## ORIGINATION FORM

Proposed Revisions to a Standard Plans Index  
(Please provide all information — Incomplete forms will be returned)

Index Number: 515-052  
Sheet Number (s): 5  
Index Title: Pedestrian/Bicycle Railing (Steel)

Sheet 5- Added knuckled selvage as an option to the chain-link railing option

**TYPE 2 - CHAIN-LINK (Continuous Infill Panel)**

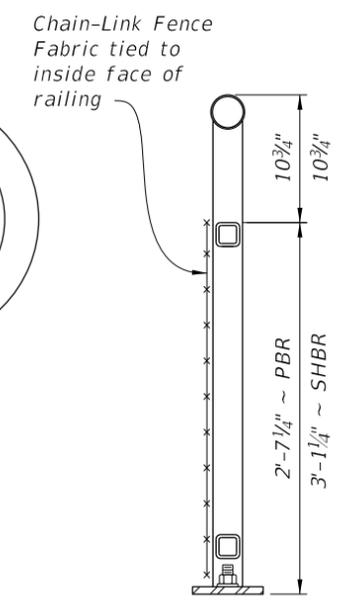
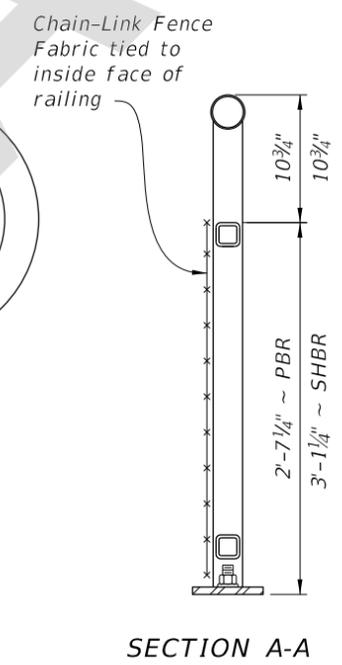
The selvage requirements detailed on Index 515-052 were based on a conservative approach to secure the bottom edge. Using knuckle selvage top and bottom would be acceptable.

TABLE 2 - CHAIN-LINK PANEL COMPONENT MATERIALS		
COMPONENT	ASTM	COMPONENT INFORMATION
Chain-Link Fence Fabric (2" mesh with <del>knuckled top and twisted bottom and knuckled top selvage</del> )	A 392	Zinc-Coated Steel - No. 9 gage (coated wire diameter), Class 2 Coating
	A 491	Aluminum-Coated Steel - No. 9 gage (coated wire diameter)
	F 668	Polyvinyl Chloride (PVC) Coated Steel - No. 9 gage Zinc-Coated Wire (metallic-coated core wire diameter) ~ See Plans for specified color of PVC.
Tie Wires	F 626	Zinc-Coated Steel Wire - No. 9 gage with coating to match Chain-Link Fence Fabric.
Tension Bars	F 626	3/16" (Min. thickness) x 3/4" (Min. width) x 2'-3' (Min. height) Steel Bars
Miscellaneous Fence Components	F 626	Zinc-Coated Steel

TABLE 2 - CHAIN-LINK PANEL COMPONENT MATERIALS		
COMPONENT	ASTM	COMPONENT INFORMATION
Chain-Link Fence Fabric (2" mesh with knuckled top and bottom selvage)	A 392	Zinc-Coated Steel - No. 9 gage (coated wire diameter), Class 2 Coating
	A 491	Aluminum-Coated Steel - No. 9 gage (coated wire diameter)
	F 668	Polyvinyl Chloride (PVC) Coated Steel - No. 9 gage Zinc-Coated Wire (metallic-coated core wire diameter) ~ See Plans for specified color of PVC.
Tie Wires	F 626	Zinc-Coated Steel Wire - No. 9 gage with coating to match Chain-Link Fence Fabric.
Tension Bars	F 626	3/16" (Min. thickness) x 3/4" (Min. width) x 2'-3' (Min. height) Steel Bars
Miscellaneous Fence Components	F 626	Zinc-Coated Steel
